Serial No. 10/627,806  
Amdt. dated September 14, 2005  
Reply to Office Action of June 14, 2005

Docket No. P-0549

**Amendments to the Drawings:**

FIG.1

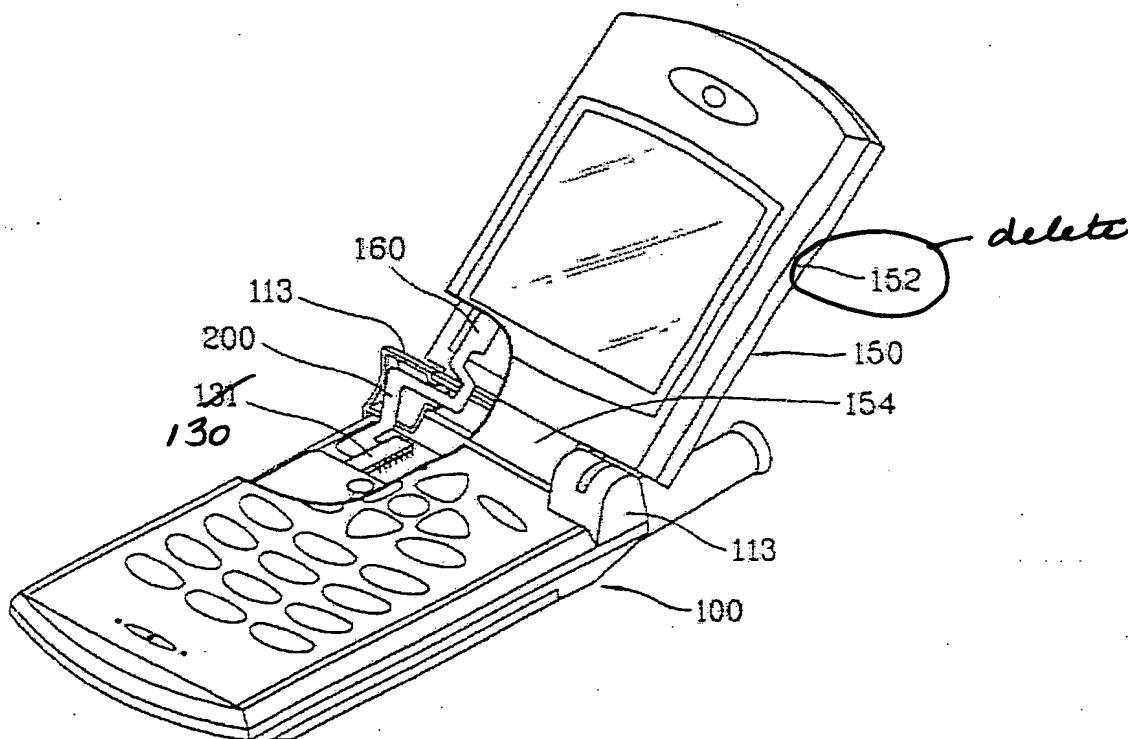
Figure 1 is amended to delete reference numeral 152, and to replace reference numeral 131 with reference numeral 130, consistent with the specification. Figure 3 is amended to reflect the proper placement of the reference line for the speaker 51. Figure 5 is amended to replace reference numerals 83 and 98 with reference numerals 68 and 93, respectively, consistent with the specification. No new matter is added.
